service bulletin

M76-8
FAA-DER Approved

SUBJECT: INTAKE VALVE CHANGE

MODELS AFFECTED: C75, C85, C90, O-200, O-300, AND GO-300

FIGURE 1.

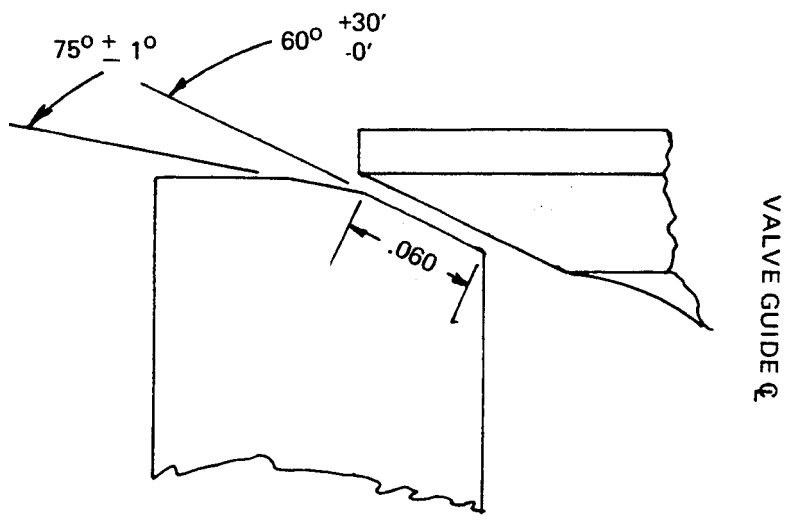
It is permissible to install the new valve on the old 45° seat insert after first grinding it to the correct angle as shown in Figure 1. However, installation of the new insert (P/N 641793) is highly desirable and both the new intake valves which supersede P/N 531608 and the new inserts which supersede P/N 3912, should be installed at the next top overhaul or major overhaul, whichever comes first.

If you install these new intake valves in cylinders which incorporated valve P/N 531608 (see cylinder part numbers listed under - "old") it is necessary to regrind the intake valve seat insert to 60°, +30' -0', to the valve guide axis to obtain a 0.060" (approx.) seat width. The seat O.D. must be kept within the O.D. of the valve face as per Figure 1. If reducing the O.D. is required, it can be accomplished with a second grind of 75°, +/- 1° as indicated.

It should be pointed out here that this valve design is commonly referred to as a "30° angle valve"; however, the standard design practice is to dimension the valve face angle off of the valve stem centerline and the valve seat insert off of the valve guide centerline; thus, the 60° shown in the sketch.
